Model: Kingfisher2			Date: 28-Dec-00		-00	No.: RA298006	
Subject: DF Harness damage				Prepared by: M.Ishihara			
From: Technical Services Dept., GTS Division							
Classification:	☑ Troubleshooting	☐ Part inf	orma	tion	Action	tion required	
	☐ Mechanical	☐ Electric	al		☐ Servi	ce manual revision	
	☐ Paper path	☐ Transm	nit/rec	eive	☐ Retrofit information		
	Other ()

Technical Bulletin

Date: 28-Dec-00 No.: RA298006

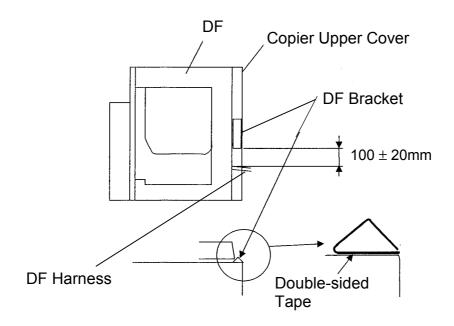
SYMPTOM:

Damage to the harness connecting the DF44 and the copier.

CAUSE:

Sometimes, the DF is forced past its normal stop position when it is opened. If this happens many times, the harness may be damaged.

- 1. User Instruction
 - Request the users not to force the DF past the stop position when they open it.
- 2. DF Bracket

A DF bracket (PN A2989500) has been registered as a service part. Place it on the copier upper cover as shown below to prevent the DF unit from being forced too far back.
